**BelGAS P134**

Scope: This is the specification and release of the BelGAS P134 pressure reducing regulator offering, a new variation of the existing P133.

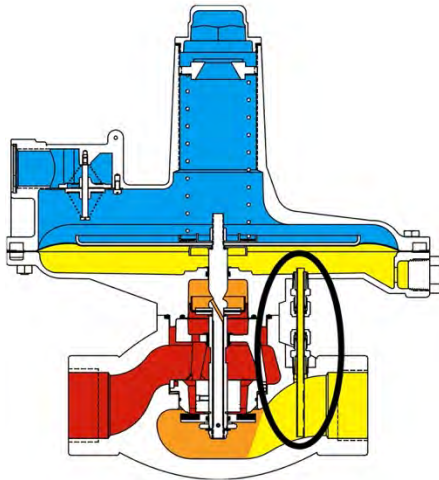
The P134 has an onboard registration tube, circled in the figure at left, allowing for the regulator to be installed without the external pressure registration necessary on the P133.

All existing [P133](#) flow and pressure information is applicable to the P134. All existing P133 body/vent orientations, body connections, spring ranges, and trim options are available with the P134. The fourth character is changed to a “4” in the existing BelGAS P133 ordering matrix.
